Council Agenda Report

City Council Meeting
10-21-26
Item 1.A.

Subject: Appeal of Planning Commission Resolution No. 26-10 Regarding Coastal Development Permit No. 23-034 (33008 Pacific Coast Highway, APN 4473-017-009, Owner Bluff Top 1 LLC, Appellant Mark Mackey) (Continued from September 23, 2026)

Figure 2: Aerial Map with Blue Line Stream Location

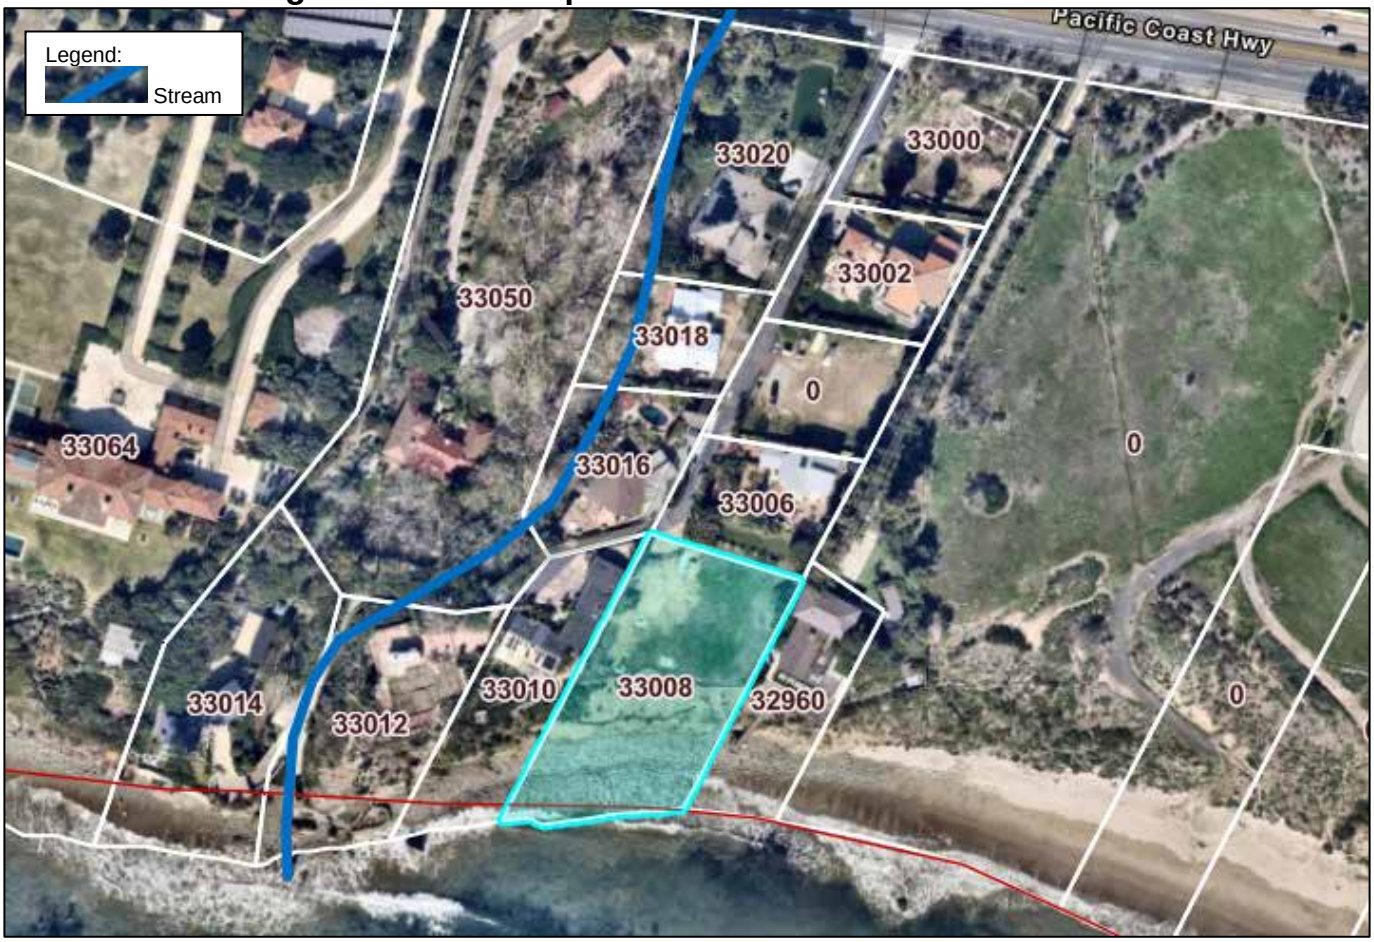
materials and confirmed that the proposed development is located 104 ft. from the mapped blue line stream to the west. It was further confirmed that the project area is located within the existing fuel modification zones of adjacent single-family residences, as shown in Figure 2 below. The figure illustrates that the existing single-family residences and access road are closer to the stream than the proposed project. Nevertheless, the proposed project maintains a 104-ft. setback from the stream, exceeding the required 100-foot buffer. As stated previously, pursuant to Land Use Plan Section 3.1, fuel modification areas required by the LACFD for existing, legal structures do not meet the definition of ESHA. Furthermore, the development is located 100 feet from the stream as required by the LCP, and no new fuel modification encroaches into the ESHA buffer zone.

DRAWING NO.
A-0.3

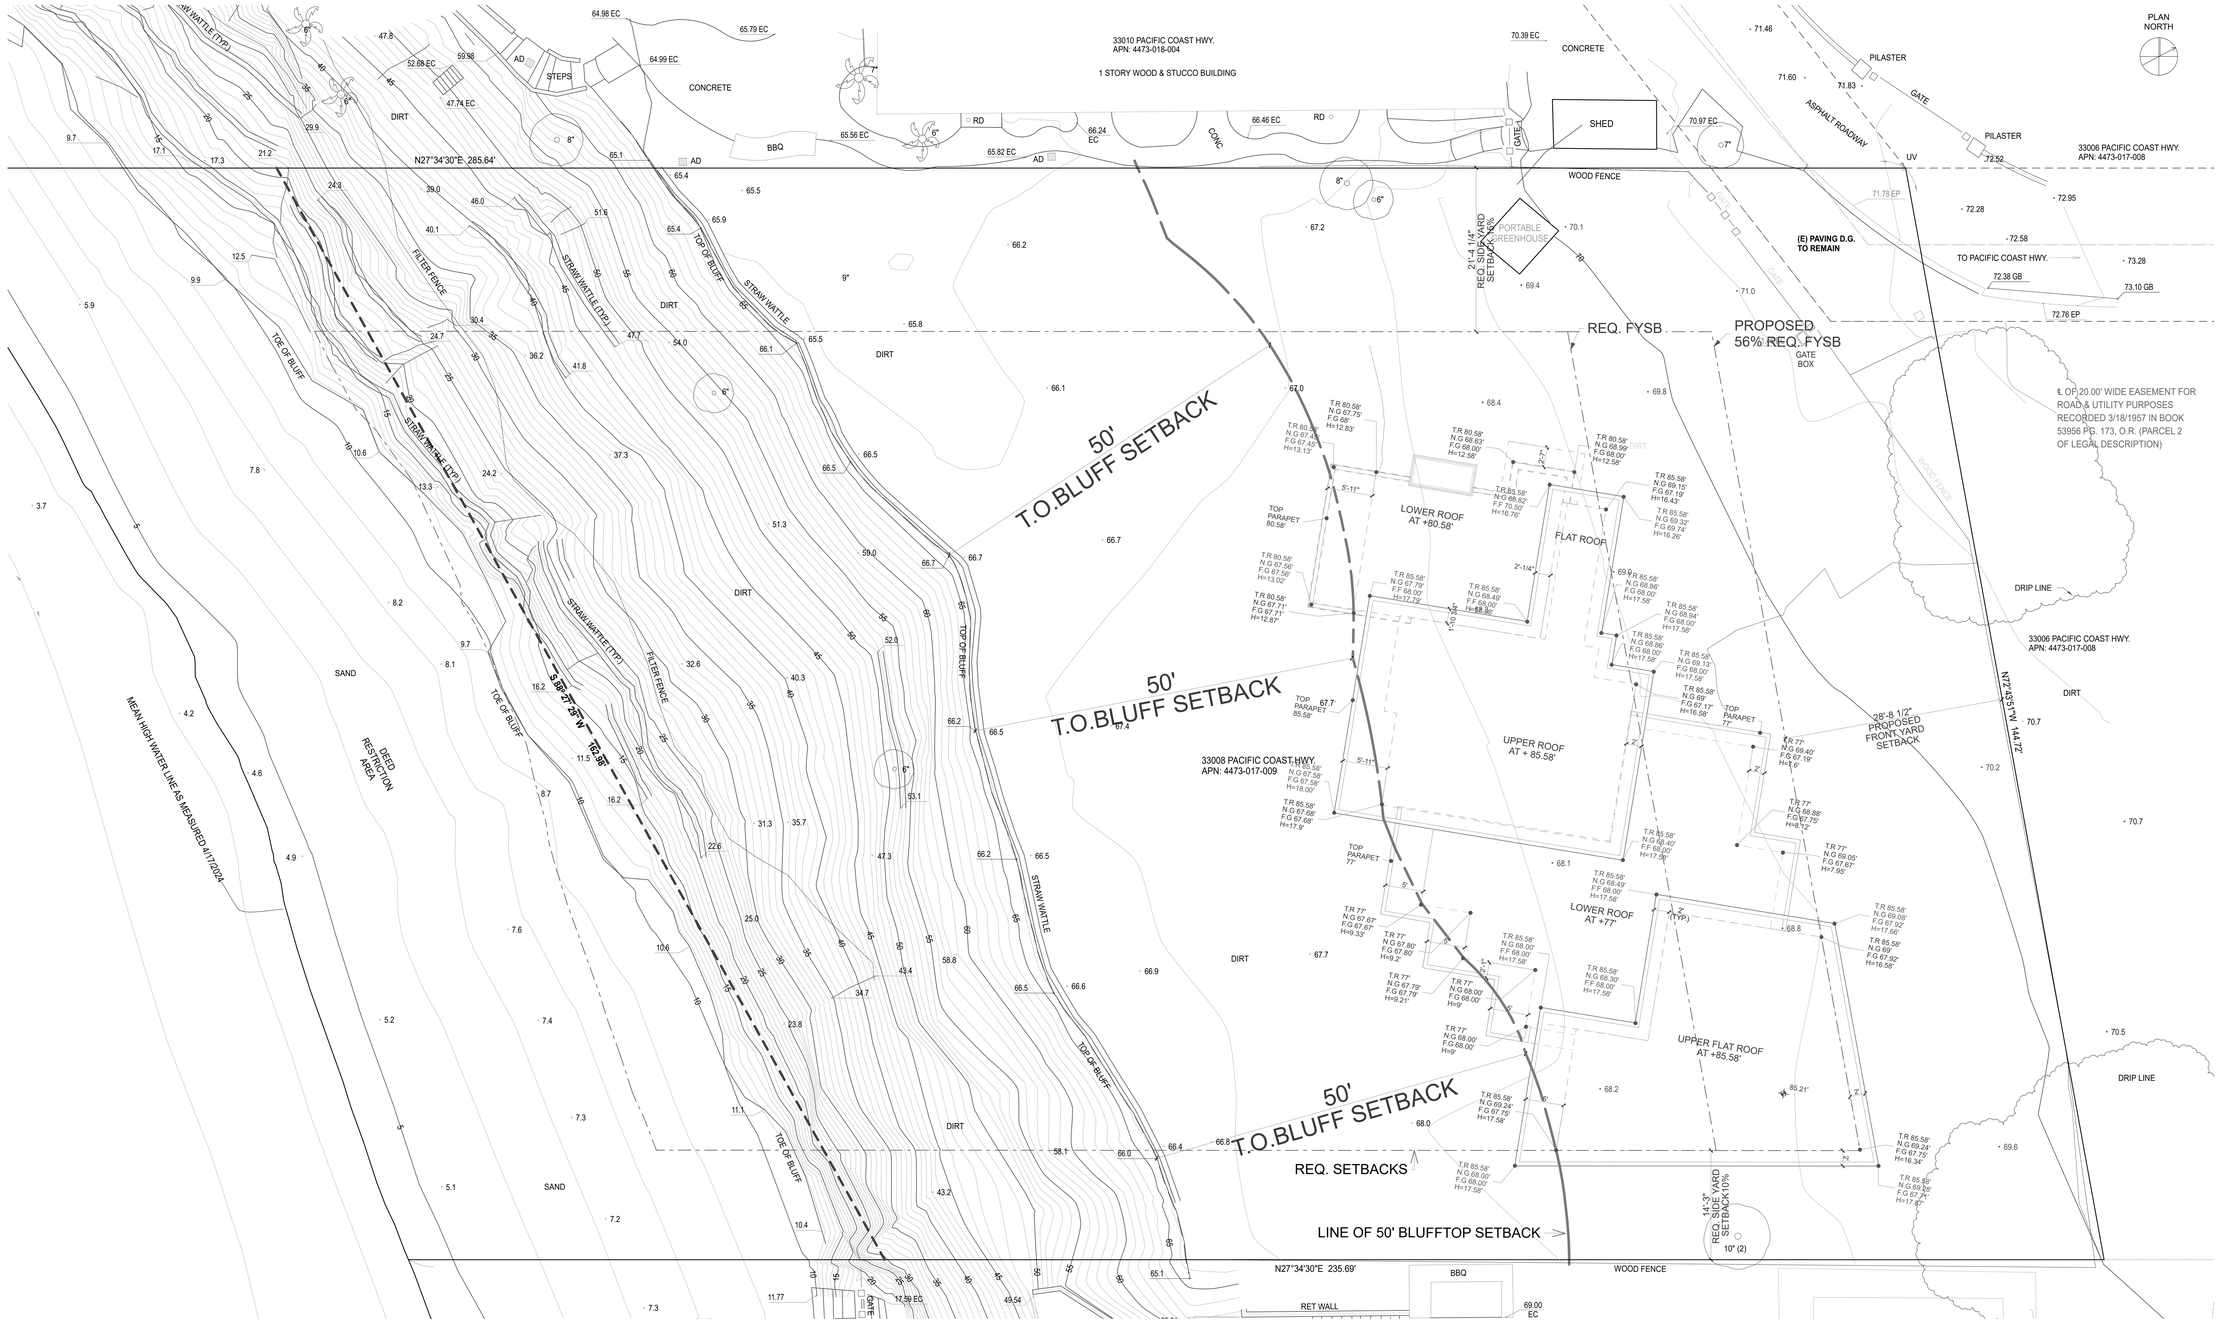
- The ESHA overlay prohibits virtually all development in ESHA buffer areas. (LIP § 4.5.4.) Ignoring these requirements, the Project proposes a new solid wall, gates, pilasters, fencing, trench drain, fire turnaround and driveway, planter boxes, landscaping, and other improvements in the ESHA buffer. (See Plans, Sheet A-0.3 [Site Plan].)

Here, the Applicant purportedly demonstrates compliance with the development area limitation on Sheet A-0.3, showing a total development area of 9,652 square feet. (See Plans, Sheet A-03.)

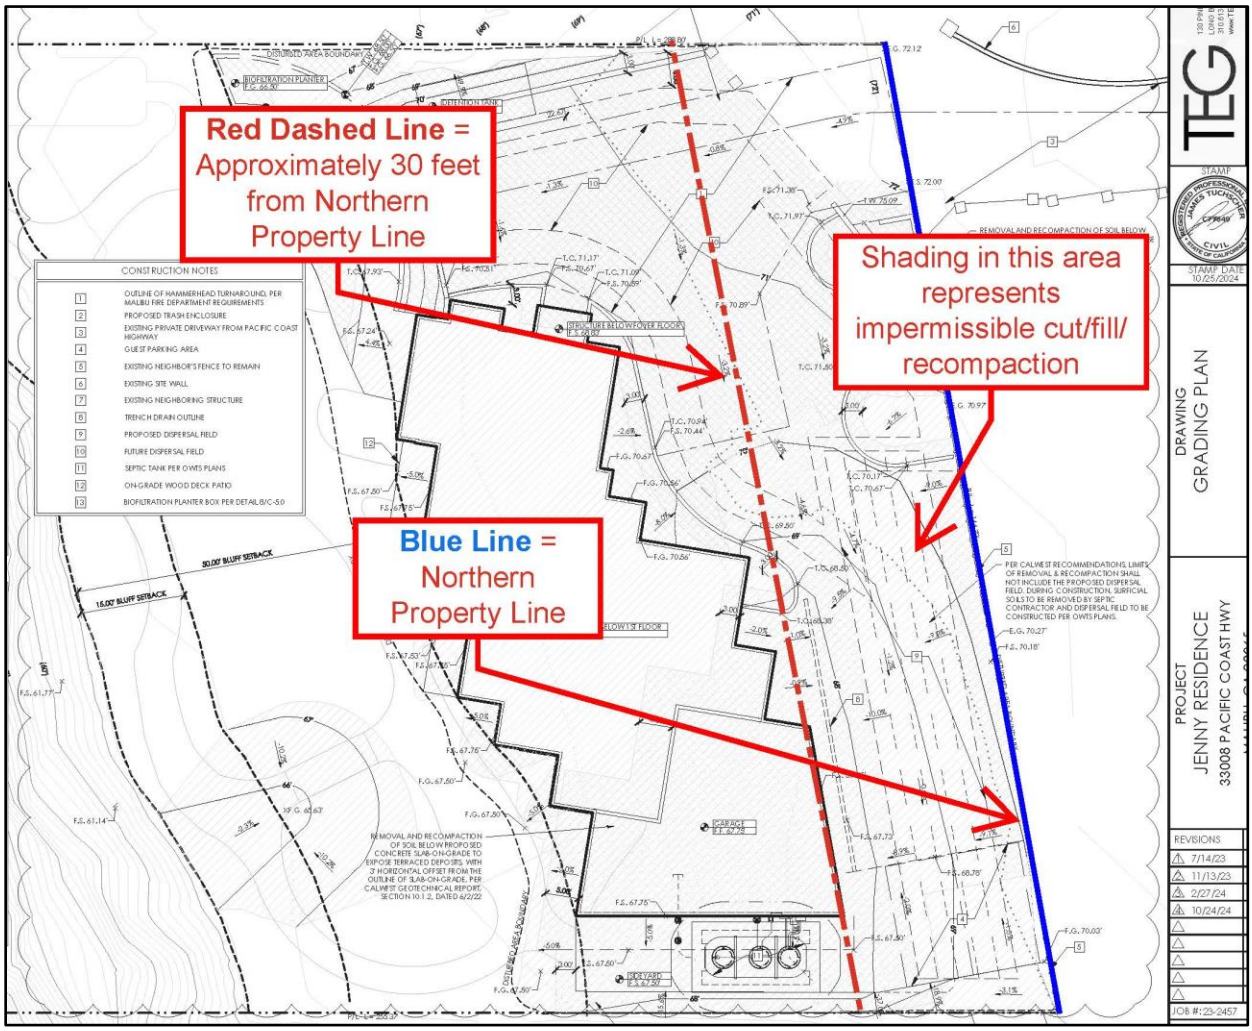
- Finally, the Applicant offers no competent evidence of surrounding fuel-modification zones. Its crudely drawn map in an email memo lacks a legend, scale, or verifiable methodology and cannot serve as substantial evidence to rebut the biological and ESHA findings discussed above.

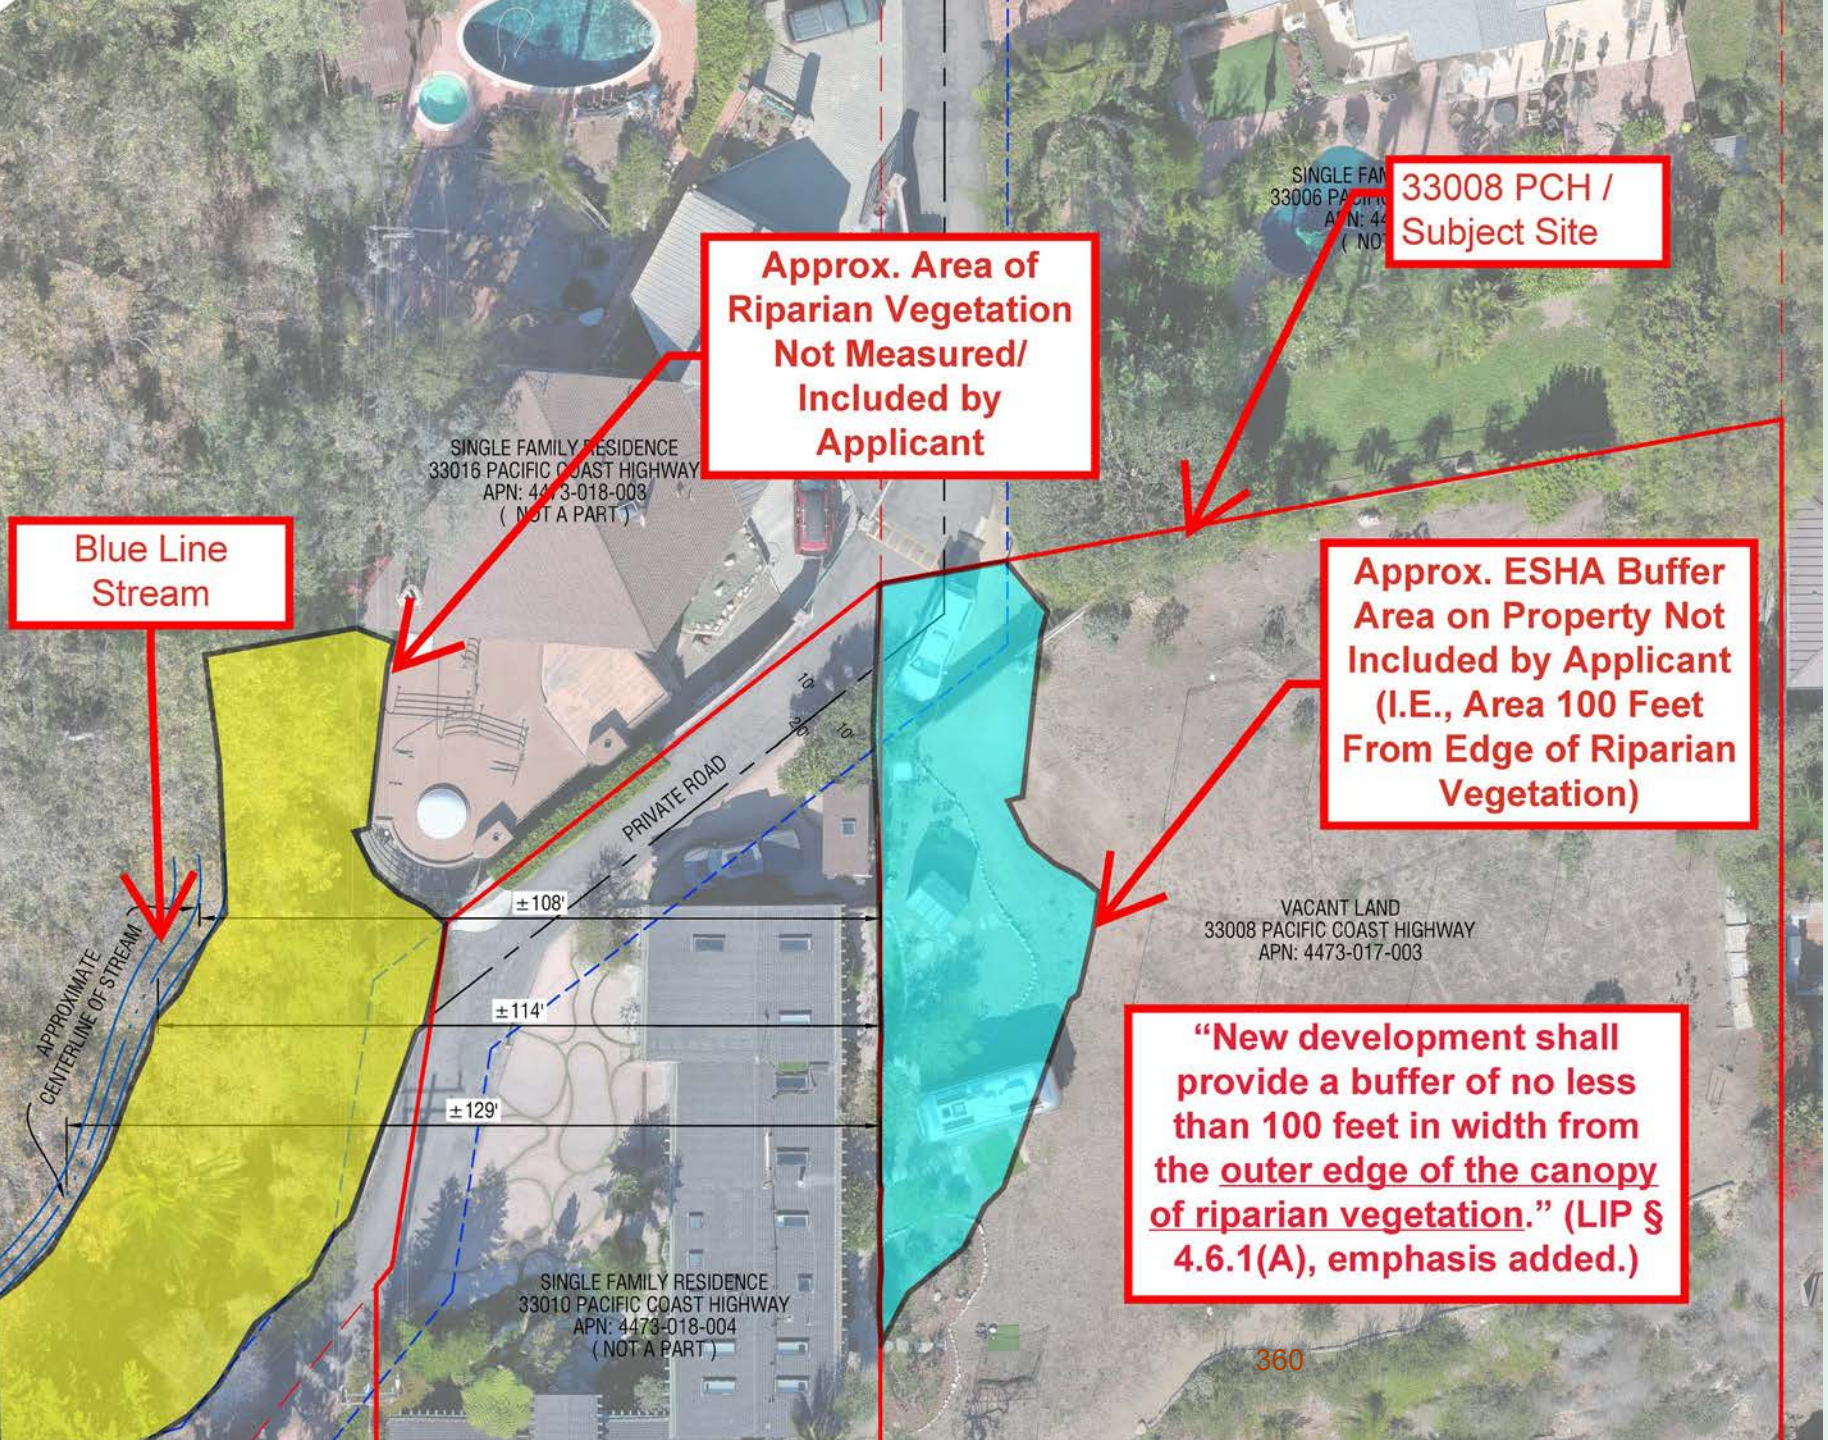
But the LIP requires development to be at least 100 feet from the edge of the riparian vegetation, not the top of the stream bank. The LIP states:

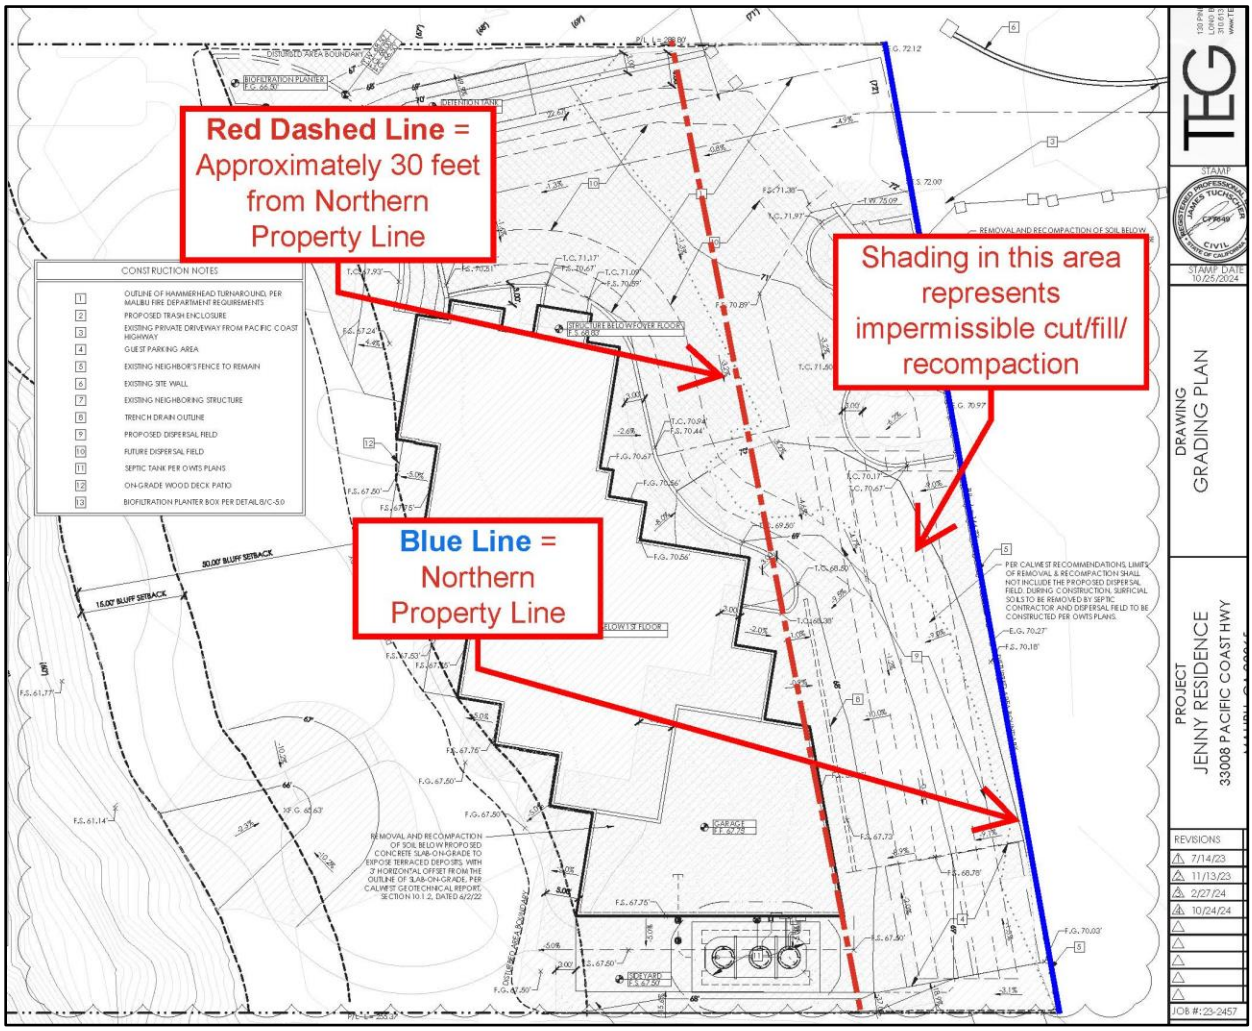
- Finally, the Applicant offers no competent evidence of surrounding fuel-modification zones. Its crudely drawn map in an email memo lacks a legend, scale, or verifiable methodology and cannot serve as substantial evidence to rebut the biological and ESHA findings discussed above.
